M3302A-01

Modification Recommended Service Note

M3302A PXIe AWG and Digitizer Combination

The ground plane clearance problem can be seen below:

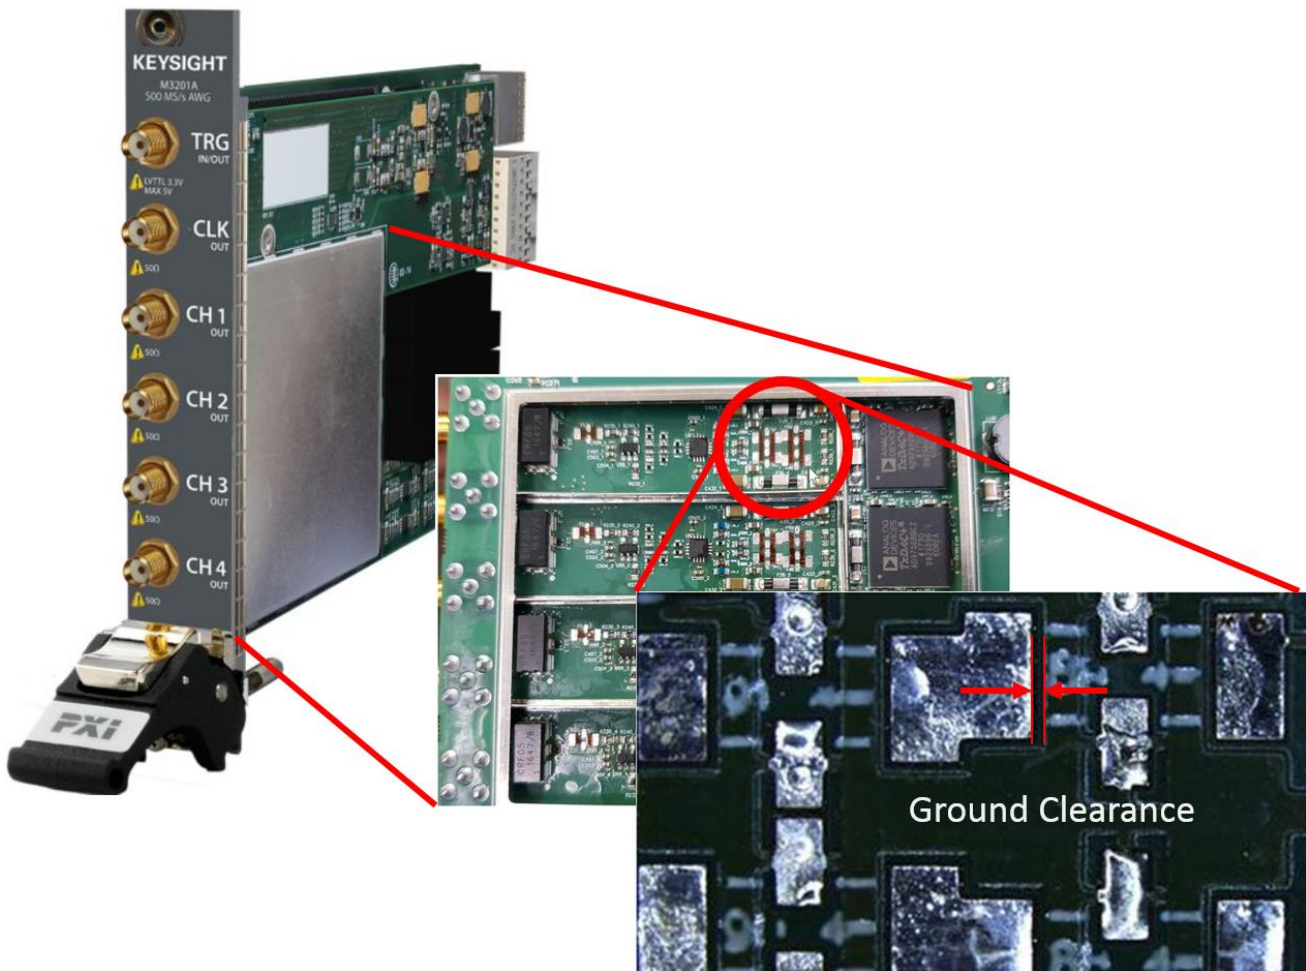
1. A possible short circuit between the filter output pad and the PCB ground plane due to insufficient ground clearance in the PCB design.
1. The performance of the filter changed sometime in 2017 which was not picked up by Keysight. This resulted in unstable DC offset performance after being in operation for some time.

These problems have been fixed in all modules, M3201A & M3202A, M3300A & M3302A from MY57510001 onwards.
